Independent Market Operator

**Draft Rule Change Report
Title: Calculation of Availability Class
Quantity Correction**

RC_2011_14

Date: 4 April 2012

Figure 1: 0 - 96 hours capacity duration curve

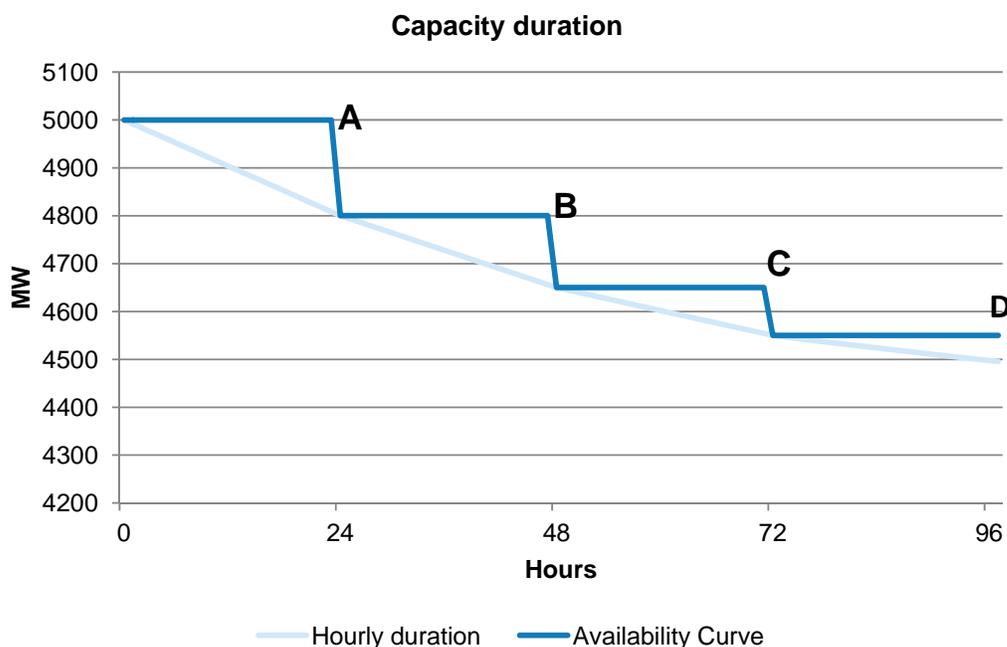
Figure 1 shows the first 96 hours of a hypothetical annual capacity duration curve, corresponding to an annual maximum capacity requirement of 5000 MW. To simplify its example, Perth Energy ignored the effects of clause 4.5.12(b) in its calculations.

Perth Energy assumed that the IMO would determine “the forecast capacity required for more than 24 hours per year” as being equal to the RCT, i.e. 5000 MW (Quantity “A”). The IMO would select a level of capacity that it only expected to be needed for one hour of the year “to take a conservative approach”. Using the same reasoning, Perth Energy assumed that the IMO would determine the forecast capacity required for more than 48 hours per year, 72 hours per year and 96 hours per year as 4800 MW, 4650 MW and 4550 MW respectively. The resulting association of capacity to the Availability Classes under clause 4.5.12(c) would therefore be:

However, Perth Energy’s assumption is not correct. Clause 4.5.12(a) contains no suggestion that the forecast capacity quantities should be inflated to build in additional conservatism. From the capacity duration curve it is clear that no more than 4800 MW of capacity (Quantity “B”) is required for *more than* 24 hours per year. The IMO considers that to determine “the forecast capacity required for more than 24 hours per year” as being greater than 4800 MW would be incorrect and in breach of the Market Rules.

For this example the IMO would determine the forecast capacity required for more than 24 hours per year, more than 48 hours per year, more than 72 hours per year and more than 96 hours per year as being 4800 MW, 4650 MW, 4550 MW and 4500 MW respectively. Under the current Market Rules, the resulting association of capacity to the Availability Classes would be:

The IMO considers that the capacity associated with Availability Class 4 should be (ignoring any impacts of clause 4.5.12(b)) the capacity that is required for *up to 24 hours per year*, i.e. the total RCT less the capacity that is required for *more than 24 hours per year* (not 48 hours as currently prescribed in clause 4.5.12(c)(i)). In Perth Energy’s example, this would be 200 MW (5000 MW – 4800 MW). To ensure this capacity requirement is met, any capacity assigned to Availability Class 4 must be available to the market for *at least 24 hours per year*. The IMO considers that this approach provides an adequate degree of conservatism.

Continuing with this example, the capacity associated with Availability Class 3 should be the capacity that is required for *up to 48 hours per year, but for more than 24 hours per year*, i.e. the total RCT less the capacity that is required for *more than 48 hours per year*, less the capacity that is assigned to Availability Class 4. This would be 150 MW (5000 MW - 4650 MW – 200 MW). To ensure this capacity requirement is met, any capacity assigned to Availability Class 3 must be available to the market for *at least 48 hours per year*.

The capacity associated with Availability Class 2 should be the capacity that is required for *up to 72 hours per year, but for more than 48 hours per year*, i.e. the total RCT less the capacity that is required for *more than 72 hours per year*, less the sum of the capacity quantities assigned to each of Availability Classes 3 and 4. This would be 100 MW (5000 MW – 4550 MW – (200 MW + 150 MW)). To ensure this capacity requirement is met, any capacity assigned to Availability Class 2 must be available to the market for *at least 72 hours per year*.

The remainder of the RCT, or 4550 MW (5000 MW – (200 MW + 150 MW + 100 MW)) should be assigned to Availability Class 1. The Market Rules (and in particular clause 4.11.4 and Appendix 3) dictate that only generation capacity is assigned to this Availability Class.
